Access Compliance Report

Public Rights-of-Way (Curb Ramps)

Intersection ID: 52926	Main Street: WALTHAM_LN	Cross Street: EMORY_OAK_DR	Location: NW
ADA ID: 326B1CC36165	Ramp Type: BlendTrans1	Initial Pass/Fail: Fail	Overall Compliance: No
Severity Score: 8.75			
Codes/Mitigation Info/Possible Solution		Field Measurements/Component Compliance

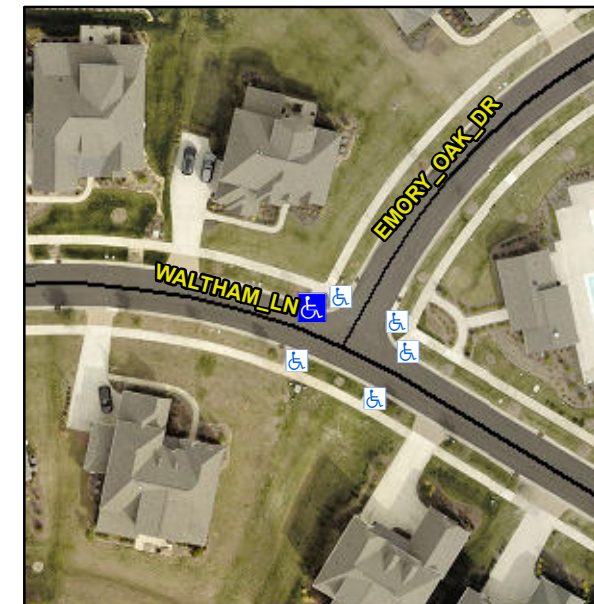
Not Found, R304.5.1

Remove & Replace Curb Ramp With Two New Directional Ramps or Equivalent.
